WESTFIELD-WASHINGTON TOWNSHIP
ADVISORY PLAN COMMISSION

October 17, 2016
1606-DDP-20

Petition Number: 1606-DDP-20

Request: Detailed Development Plan approval for a 12,900 square foot+/- pharmacy building on 1.96 acres+/- in the Mixed Use District of the Harmony Planned Unit Development (PUD) District.

- d) Neighborhood commercial uses in the Mixed Use District shall be designed to encourage the design elements shown in Exhibit C-2.

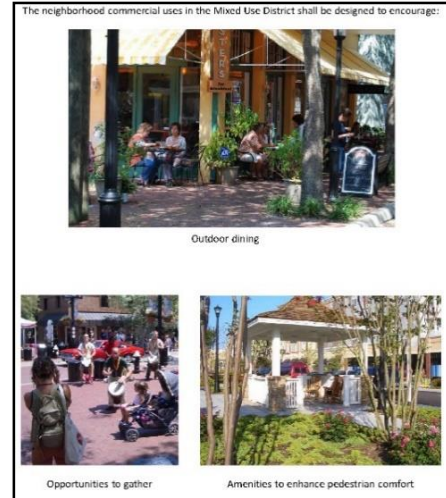
Comment: Exhibit C-2 (image to the right) includes the following design elements: (i) outdoor dining; (ii) opportunities to gather; and (iii) amenities to enhance pedestrian comfort.

The petitioner has proposed a park bench along the lot's Ditch Road frontage as an amenity to enhance pedestrian comfort.
